AUDIT FOR MARK I CONTAINMENT LONG-TERM PROGRAM -
STRUCTURAL ANALYSIS FOR OPERATING REACTORS

COMMONWEALTH EDISON COMPANY
QUAD CITIES NUCLEAR GENERATING STATION UNITS 1 AND 2

TER-C5506-325

AUDIT FOR MARK I CONTAINMENT LONG-TERM PROGRAM -
STRUCTURAL ANALYSIS FOR OPERATING REACTORS

Figure 1. Strain Gauge Locations on RCIC Turbine Exhaust Line

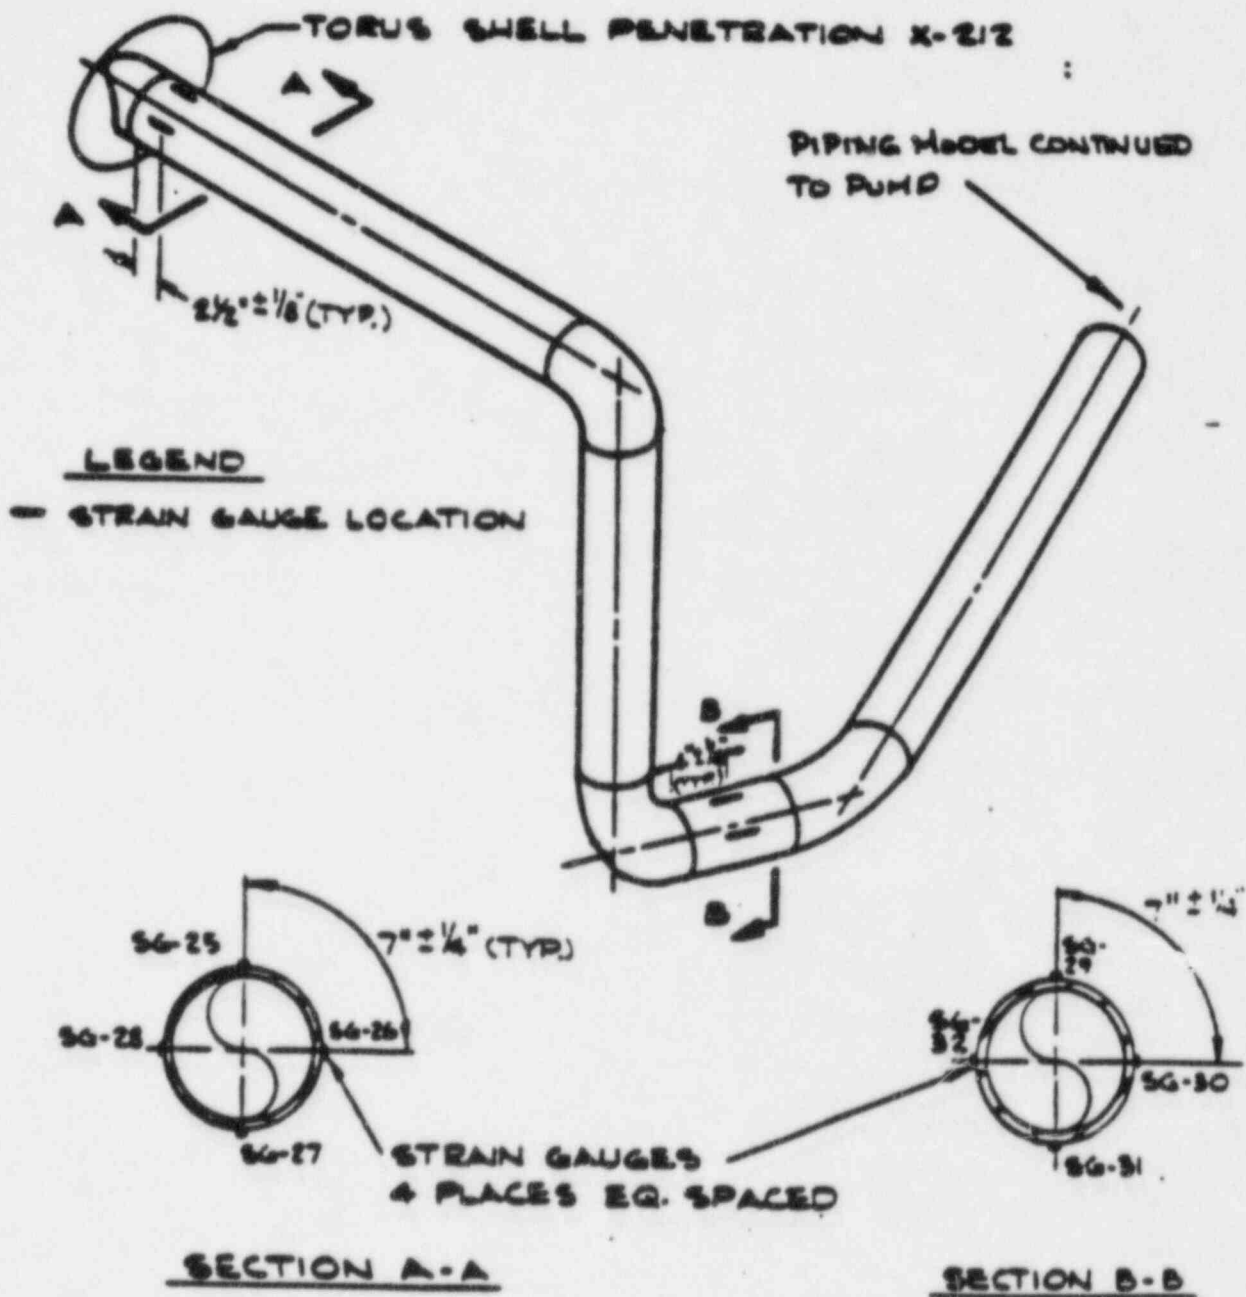
In-plant SRV tests performed at the Monticello plant in 1980 were used as a basis for verification of the CMDOF program. Test data from five tests were selected for comparison. Specifically, data from strain gauges located on the

RCIC turbine exhaust line (RS3-8 in-HE) approximately 1 foot and 20 feet from the torus penetration, as shown in Figure 1, were used for comparison. The tests were conducted by actuating one safety relief valve under cold pipe and normal water leg conditions with a reactor power level of 80%. Plots of strain time histories were recorded during each test and were compared directly with the predicted values obtained by the CMDOP program.

The Monticello SRV test strain gauge data (converted to stress) were compared with the predicted stresses obtained by the CMDOP program. The responses on the time domain and frequency domain (by Fourier transformation) at strain gauge locations were compared with those obtained by the analysis. In addition, the maximum stress values were used in the comparison. The results indicated that a factor of conservatism in excess of 3 was observed in the analysis.

Based on FRC's review of various stress time histories and the maximum stress level of the test data and analysis, it is observed that there is conservatism associated with the analytical procedures. This conservatism could be attributed to the following sources: methodology by which loads were generated, low damping values used in the analysis, possible nonlinearity resulting from pipe supports. The comparison between the test and predicted

values indicated that there is conservatism associated with the analytical procedures, which provides a basis for alleviating the concerns related to some calculated stress values presented in the Licensee's original submittals.
